TURKEY POINT NUCLEAR GENERATING STATION UNIT 3 AND UNIT 4

IMPROVED TECHNICAL SPECIFICATIONS CONVERSION

ITS SECTION 3.7 PLANT SYSTEMS

Revision 0

4 **INSERT 2**

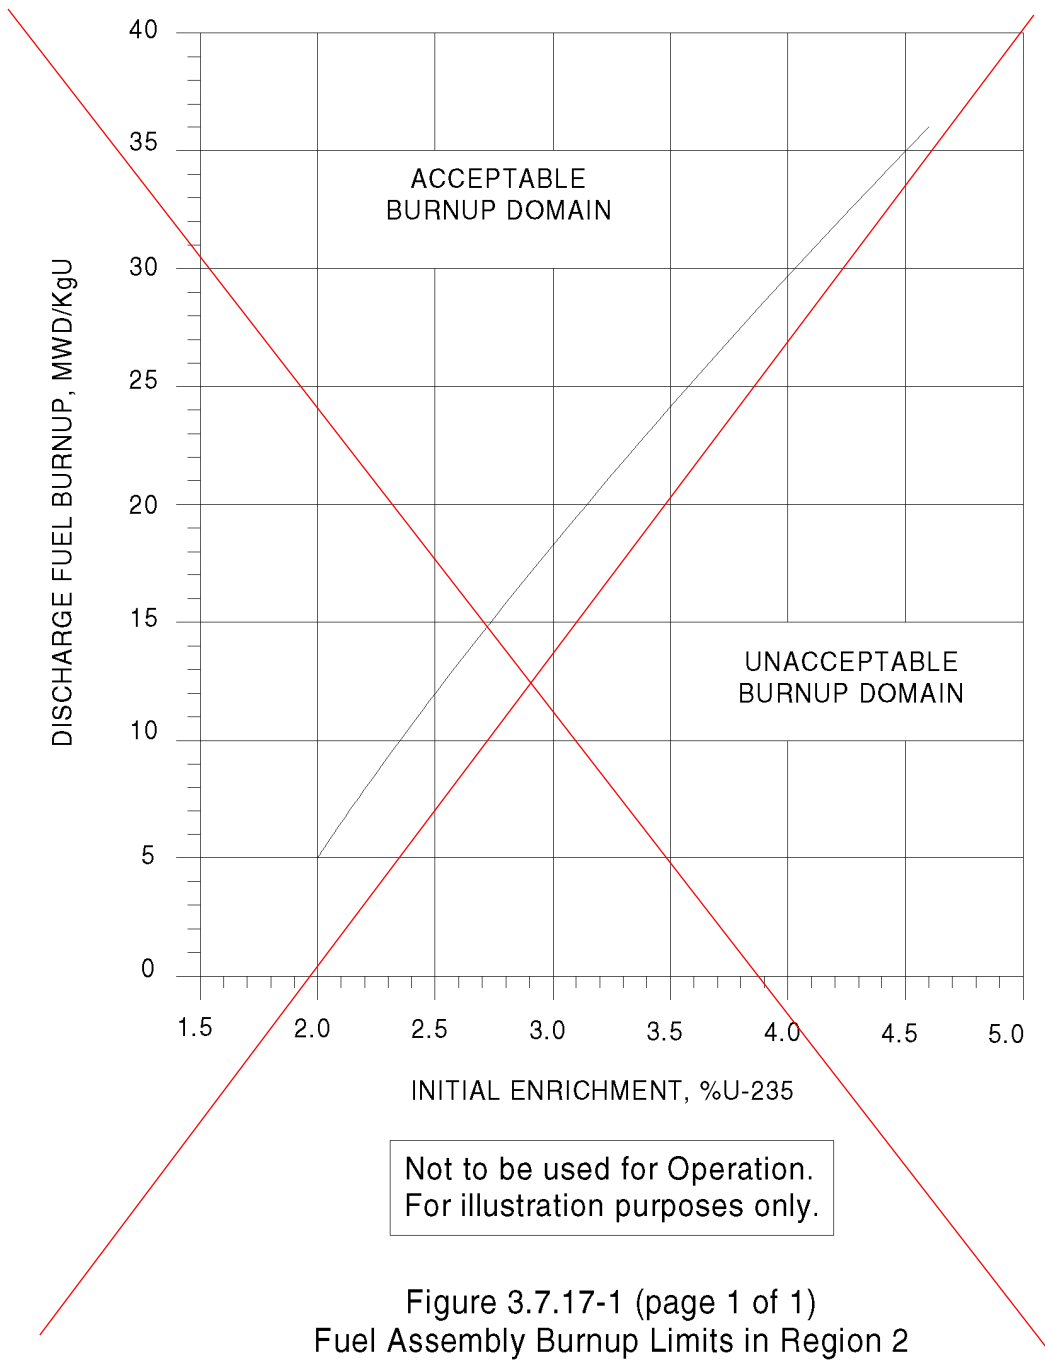
Fuel assemblies stored in Region I and II shall be stored in accordance with the requirements of Figures 3.7.14-1 through Figure 3.7.14-3 with credit for burnup and cooling time taken in determining acceptable placement locations for spent fuel in the two-region spent fuel racks. Fresh or irradiated fuel assemblies in the Region I or Region II racks shall be stored in compliance with the following:

- a. Any 2x2 array of Region I storage cells containing fuel shall comply with the storage patterns in Figure 3.7.14-1 and the requirements of Tables 3.7.14-1 and 3.7.14-2, as applicable. The reactivity rank of fuel assemblies in the 2x2 array (rank determined using Table 3.7.14-3) shall be equal to or less reactive than that shown for the 2x2 array.

- b. Any 2x2 array of Region II storage cells containing fuel shall:
 - i. Comply with the storage patterns in Figure 3.7.14-2 and the requirements of Tables 3.7.14-1 and 3.7.14-2, as applicable. The reactivity rank of fuel assemblies in the 2x2 array (rank determined using Table 3.7.14-3) shall be equal to or less reactive than that shown for the 2x2 array,

- c. Any 2x2 array of Region II storage cells that interface with Region I storage cells shall comply with the rules of Figure 3.7.14-3.
- d. Any fuel assembly may be replaced with a fuel rod storage basket or non-fuel hardware.

- e. Storage of Metamic inserts or RCCAs is acceptable in locations designated as empty (water-filled) cells.
